SUBJECT:             CERTIFICATION OF THE MINUTES FOR THE MEETING  
                          OF THE ADVANCED BOILING WATER REACTOR  
                          SUBCOMMITTEE, APRIL 6, 2011 IN ROCKVILLE,  
                          MARYLAND

**ADVISORY COMMITTEE ON REACTOR SAFEGUARDS  
ADVANCED BOILING WATER REACTOR SUBCOMMITTEE  
MEETING MINUTES  
April 6, 2011**

The purpose of the meeting was to hear presentations and discuss the information on Chapter 10 and 14 of the Safety Evaluation Report (SER) related to the Combined Operating License (COL) application submitted by South Texas Project Nuclear Operating Company (STPNOC, applicant) for two ABWR units at the South Texas Project (STP) site in Texas. The Subcommittee did not receive written comments from members of the public. There were no requests to make oral statements from members of the public regarding the Subcommittee meeting. Ms. Maitri Banerjee was the Designated Federal Official (DFO) for this meeting.

**Figure 10.2-5 Turbine Overspeed Trip System Functional Diagram**

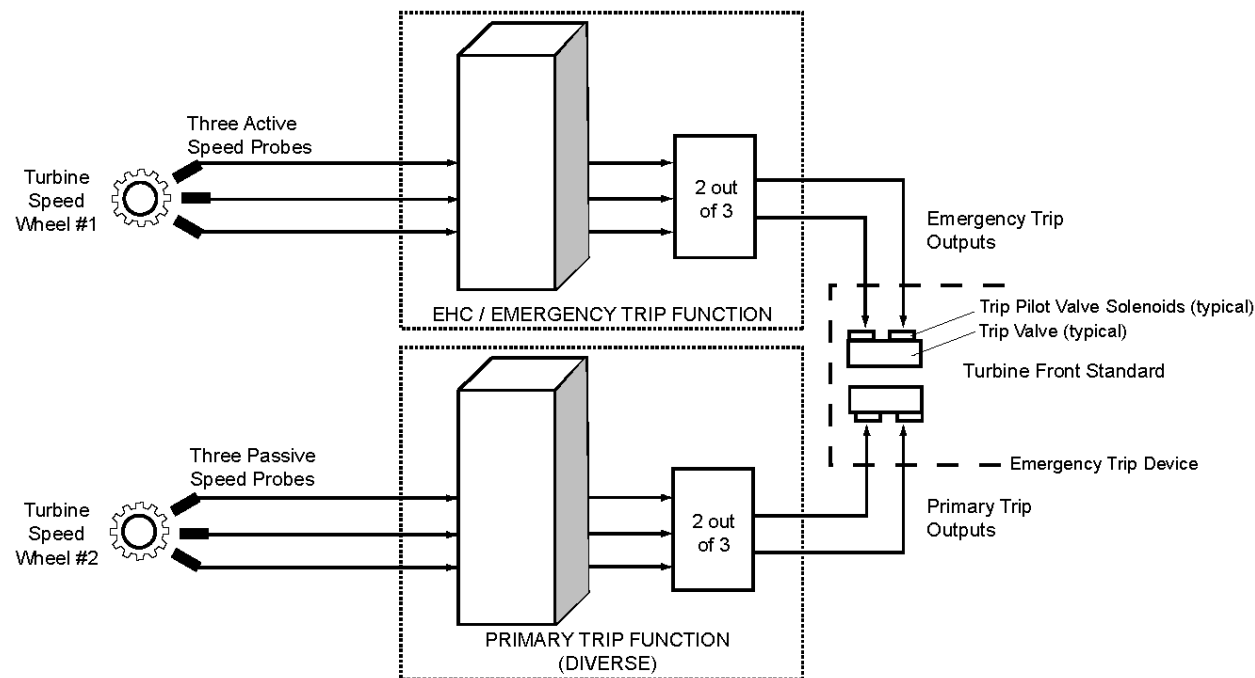
11 MEMBER BROWN: Okay. I just want to make  
12 sure after going through this and the clarifications  
13 you all added to the RAI. There are three active  
14 speed sensors that are also used for the normal speed  
15 control?

1           You made a comment and it's in your RAI in  
2     the context, it says -- it's talking about the normal  
3     speed control units. And these are the active  
4     sensors. And John addressed what's a failure. But it  
5     says if you lose any two of the speed sensors -- the  
6     active sensors -- then you will initiate a turbine  
7     trip.

8           Whatever the mode of failure, we haven't  
9     got that defined as to what defines a failure, et  
10    cetera. And in my previous reading, I kind of felt  
11    that applied to the primary diverse system also. But  
12    then I went back and looked through and I could not  
13    find that in the RAI response, anything that addresses  
14    the passive sensors such that if two of them fail --  
15    whatever the mode either -- there's no output or the  
16    output goes bananas or whatever the thing is that  
17    stays in one place -- couldn't find any reference to  
18    if you lost sensing on the primary system that you  
19    would get a turbine trip. So am I wrong?

3 MEMBER STETKAR: I think, Dinesh, my  
4 questions to the Applicant kind of get to the point of  
5 what happens if a speed signal -- two out of three  
6 speed signals go to zero speed is basically what I was  
7 looking for.

16 MR. MURRAY: That is correct.

20           MR. MURRAY: It does. It has the same  
21    function -- loss of sensor. And again, I can't answer  
22    the failure --

## **Section 10.4.7 Open Item - Condensate and Feedwater System**

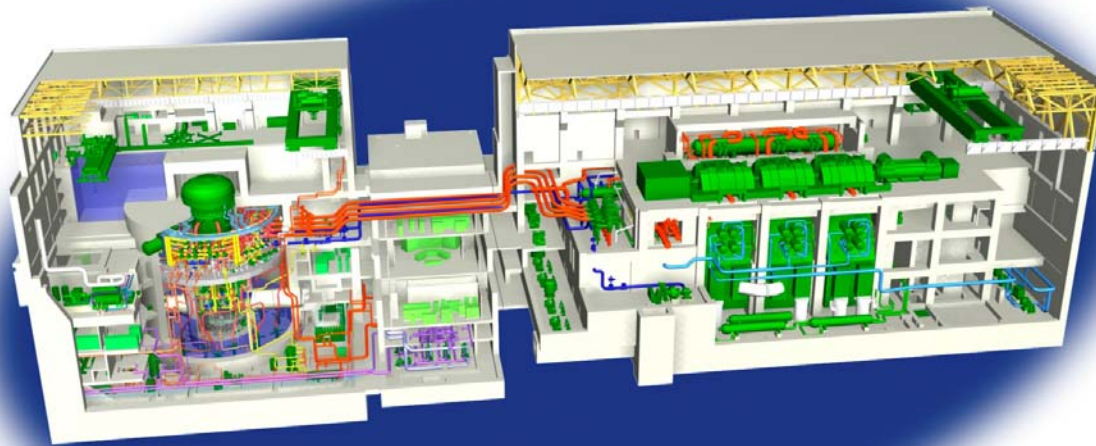
14 In reviewing that change, we looked at the  
15 Tier 1 information, and there appeared to be an  
16 inconsistency between the Tier 2 information and the  
17 Tier 1 information which they had incorporated from  
18 the DCD by reference.

19 The first slide here pretty much  
20 summarizes what the issue was when we came and talked  
21 to you last time at the ACRS meeting. And basically  
22 like I just said, we had a Tier 2 change that changed  
23 system configuration, and the Tier 1 information still  
24 reflected the DCD information which didn't incorporate  
25 condensate feedwater system that utilizes a booster

3 In resolution, they provided us with a  
4 revision to one of our earlier RAIs. And in that  
5 revision what they did was they revised the figure  
6 that the design description pointed to -- or the ITAAC  
7 pointed to design description figure to confirm that  
8 the system in the ITAAC was the system that we were  
9 approving in the design. And they updated that  
10 figure, and now the figure shows the condensate pump  
11 -- the relative location of the condensate pump. And  
12 it includes the condensate, moves the pump into Tier  
13 1 figure.

14 So based on that, we reviewed that. We  
15 looked at the Tier 2 information and with the revised  
16 RAI response, we now feel like this issue is resolved  
17 and the open item can be closed.

- The applicant proposed a new Tier 1 departure which revised Tier 1, Figure 2.10.2a.
- In the revised Figure 2.10-2a, condensate booster pumps are now included as part of the basic CFS configuration.
- The staff reviewed the proposed revisions to the Tier 1 information and found it acceptable since the information in Tier 1 is now consistent with the plant design described in Tier 2.
- Incorporation of the proposed Tier 1 change is being tracked as a confirmatory Item.

# Primary Overspeed Trip and Emergency Overspeed Trip Functions

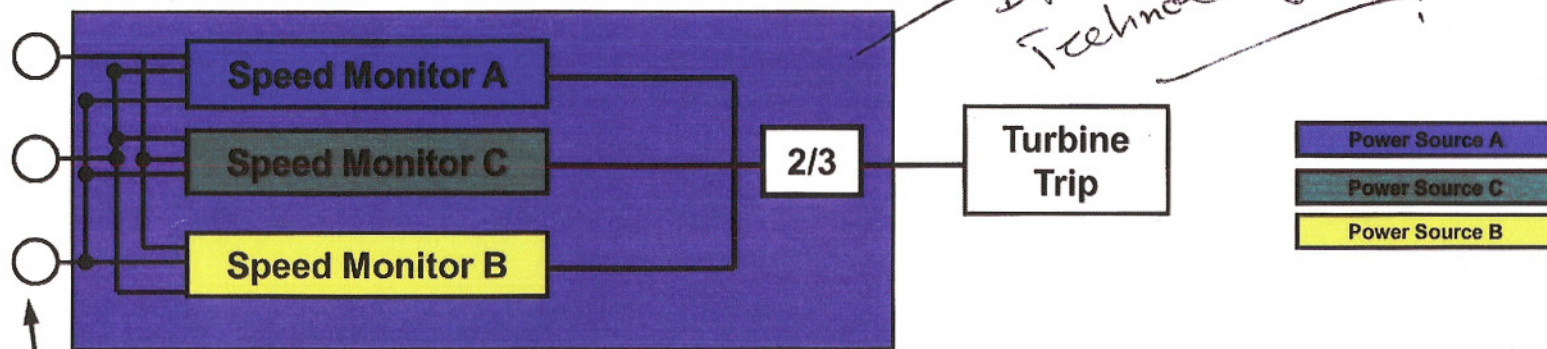
6 MR. MURRAY: What I mentioned was if they  
7 exceed setpoint. But also in the information we  
8 provided, yes, if you have one failure, you do not get  
9 a turbine trip. You go to a two out of -- or you  
10 reduce the logic -- go two out of three. But a second  
11 failure of a speed probe will provide a trip.

11 MEMBER STETKAR: Okay. So you just pick  
12 up the change in the pulses on that. So they're not  
13 powered. Then maybe I'm not so interested in that  
14 failure mode.

8 MR. MURRAY: Yes. And that is that it's  
9 basically a coil that monitors the change in  
10 magnetism.
